45654-OTH Fiordland Lobster

Restriction of access via installation of a permanent fence to the commercial port area of Deepwater Basin, Milford Sound Piopiotahi. Restriction to berth at wharf within fence

Printed name of submitter or person authorised on behalf of submitter	Noel Saxon
Organisation	Tourism Milford Limited (TML)
Date	January 2024

Figure 1 – aerial view of the site showing vehicle track and suggested revised location of fence line

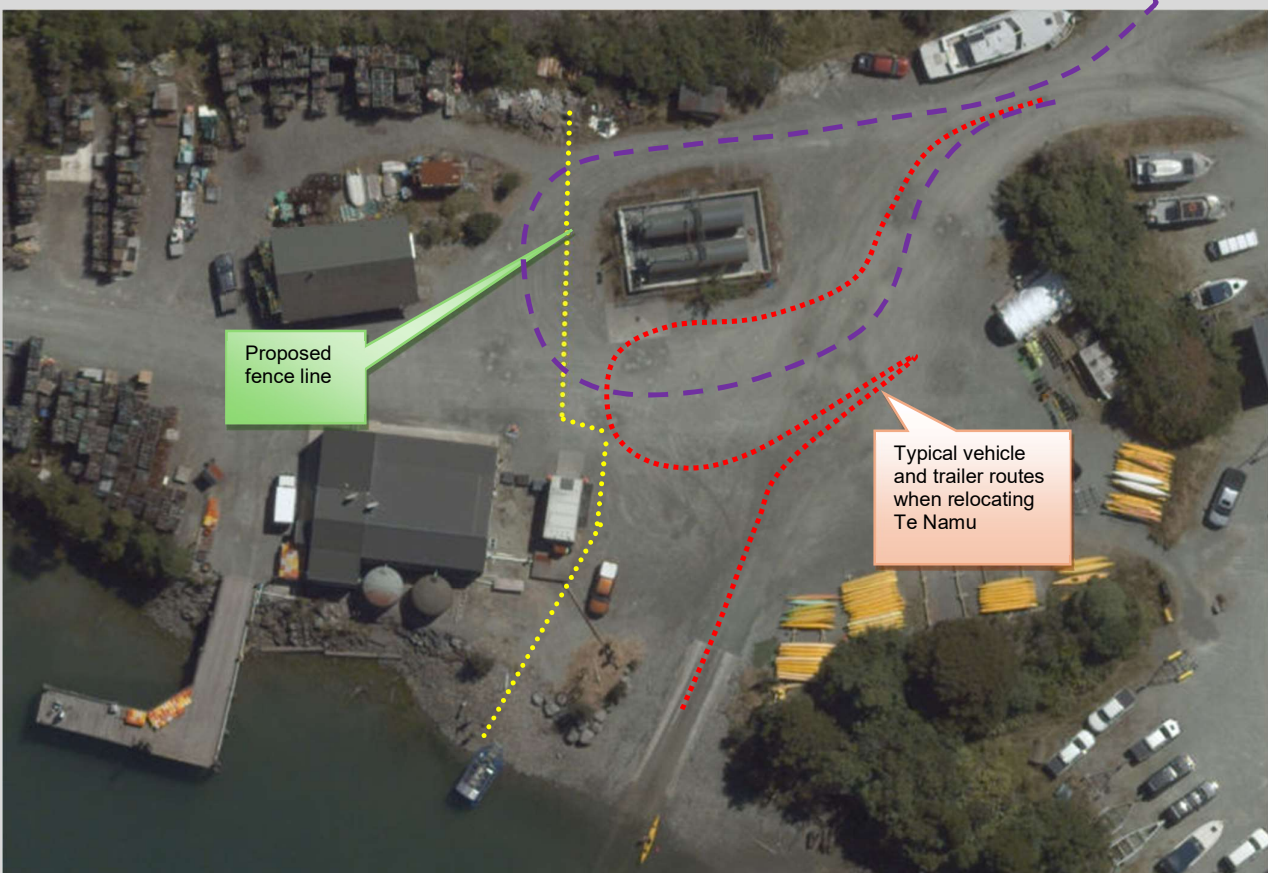
- The permanent fence location indicated in the application
- The potential removal of access to TML berth

- The permanent fence indicated in the application will make removing and returning the Te Namu (vessel that is used to transport walkers from Sandfly to Freshwater basin) impossible. The boat and trailer is large and difficult to manoeuvre especially during the busy times of the summer. The Te Namu is removed from the water on a regular basis for refuelling purposes at the petrol bowser in Milford Sound village.
- The permanent fence will also restrict access to the berth that Tourism Milford Limited require infrequently to overnight the Te Namu
- TML supports further management and improvement of the H&S risks at this site

- Redesign the fence line to ensure there is plenty of room to continue providing required access to boat ramp for removing and re-entering large vessels from deepwater basin.
- Provide stakeholders with 24/7 access to their berth..
